KNOXVILLE HISTORIC ZONING COMMISSION STAFF REPORT - CERTIFICATE OF APPROPRIATENESS APPLICATION

PROPERTY LOCATION: 1610 Forest Ave. /
Parcel ID 94 N E 015

FILE NO.: 12-F-19-HZ

LEVEL OF WORK: Level III. Construction of new primary building

1610 Forest - East

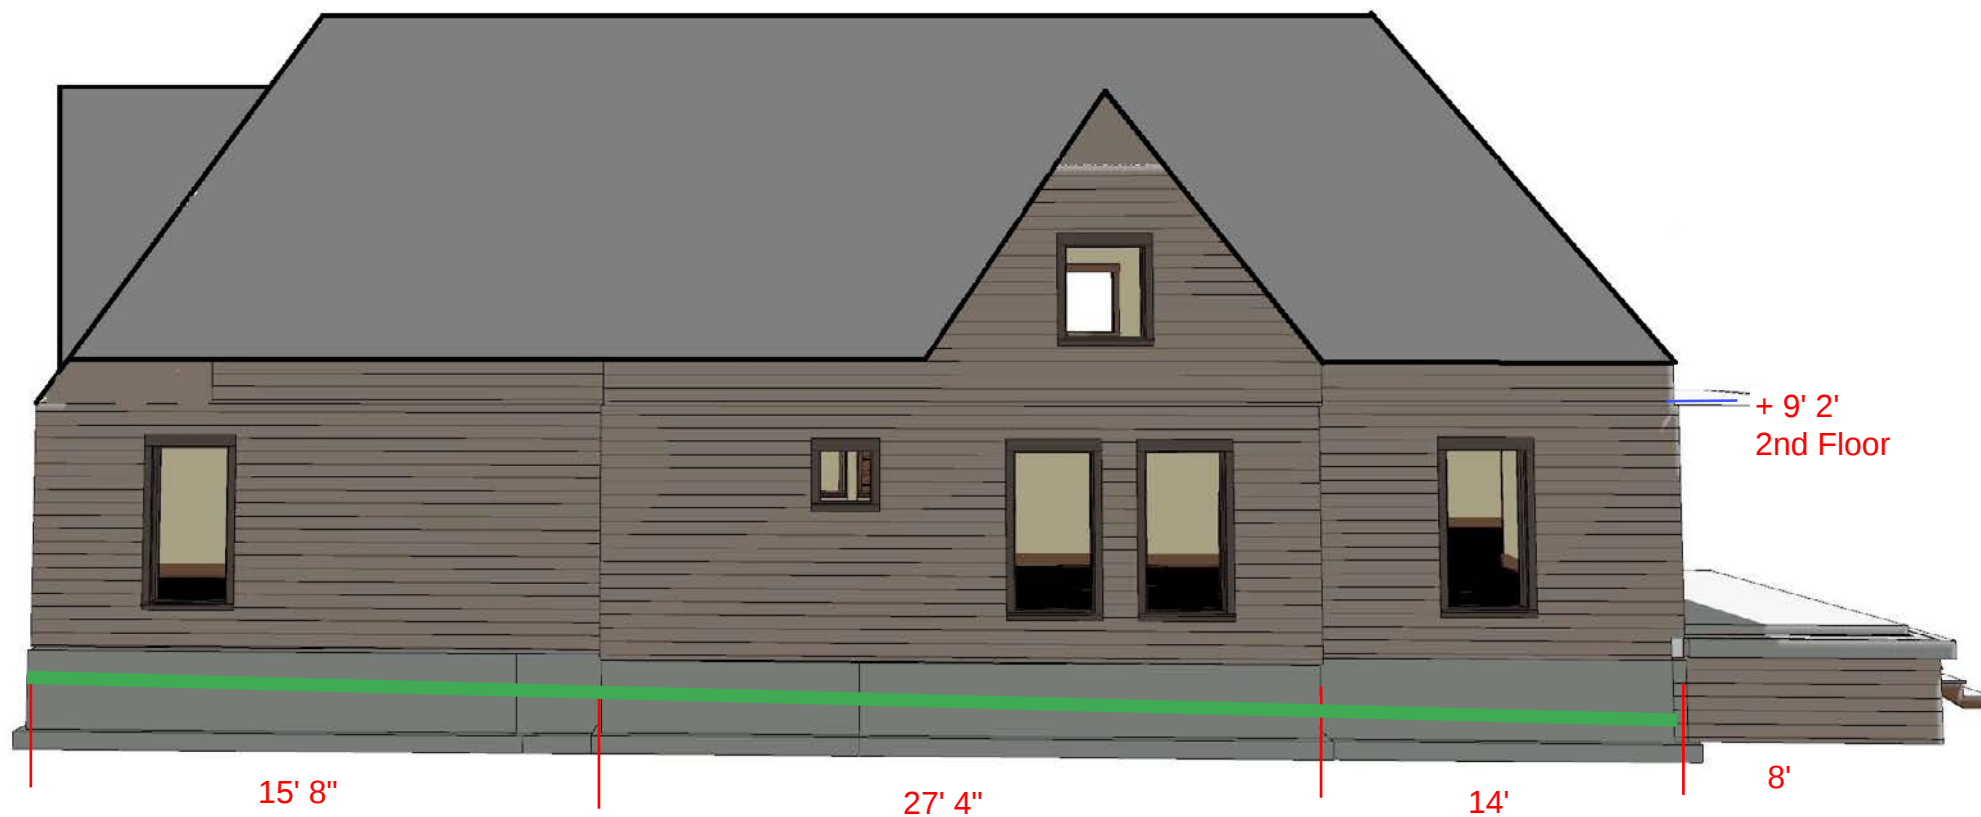
6. The hip-and-gable roofline is appropriately complex for the context. Proportions and placement of the windows on the north, west, and south elevations are appropriate and provide transparency that reflects the historic context of the neighborhood. One additional window on the rear (labeled 15'-8") section of the east elevation would provide additional transparency and better reflect historic proportions.

Staff recommends approval of the work as proposed, with the following conditions: 1) one native shade tree be planted in the rear yard, 2) one additional window be added to the rear section of the east elevation, with approval by staff, and 3) any modifications to the house's design required to meet side setback and lot coverage requirements return to the Commission as necessary.
